Author response to Reviewer 1 comment on “Carbon balance of a restored and cutover raised bog: Comparison to global trends” by Michael M. Swenson et al.

**Reviewer 1 General Comments:**

Figure caption. This figure shows the modelled and measured data for collar EC13 for ER (top), GPP (middle), and for clarity (because GPP drops to 0 every night with light level), GPP normalized by light level to show the seasonal fluctuations independent of light level (bottom).

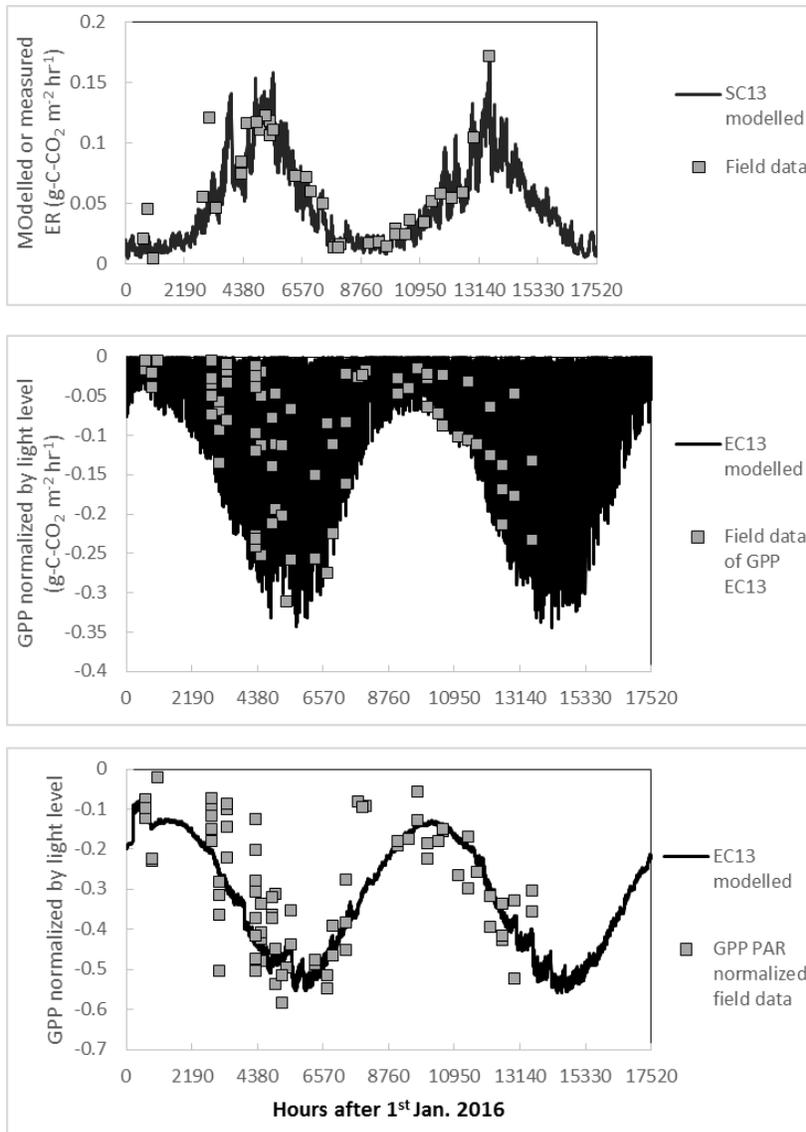
**R1 comment 20.** Figure 4 -7 - either show all modelled and observed fluxes like you do for CH<sub>4</sub>-fluxes in Figure 5a ( IWOULD HIGHLY RECOMMEND, OTHERWISE YOU SHOW TOO MUCH MODELLED RESULTS but little observed values used to derive the modelled values!) or as monthly bar plots or cumulative plots like you do for terrestrial CO<sub>2</sub>-fluxes in Fig 4. This is also probably where you can reduce your figure numbers. Fig 5b probably belongs to Supplement where you describe your model fitting.

*“like you do for CH<sub>4</sub>- fluxes”* Showing all of the modelled and measured CH<sub>4</sub> flux data was possible because the field data from all collars was lumped together before modelling.

**Response:** Moving Fig. 5b to the supplemental section is a good suggestion. Otherwise, this comment is a little perplexing: on the one hand, Reviewer 1 mentions reducing the number of figures; on the other hand, Reviewer 1 asks for more figures showing modelled and measured results. As the GPP and ER were modelled separately for each of the 29 collars, it would be confusing/misleading to show the entire field dataset and modelled results in a single plot. The modelled and measured data is shown together here for one particular collar as an example. For all 29 collars, 77 such plots (3 for each collar) would be needed, which may be excessive even for the supplemental section (although if the Editor thinks this is valuable, these plots can be included). The  $r^2$  values, although not statistically sufficient by themselves, demonstrate the modelled data correlation with field data in a much smaller format.

**Manuscript changes:** Fig 5b has been moved to supplemental section. Otherwise, no changes will be made unless the Editor requests plots like the example above to be in the supplemental section for each collar.
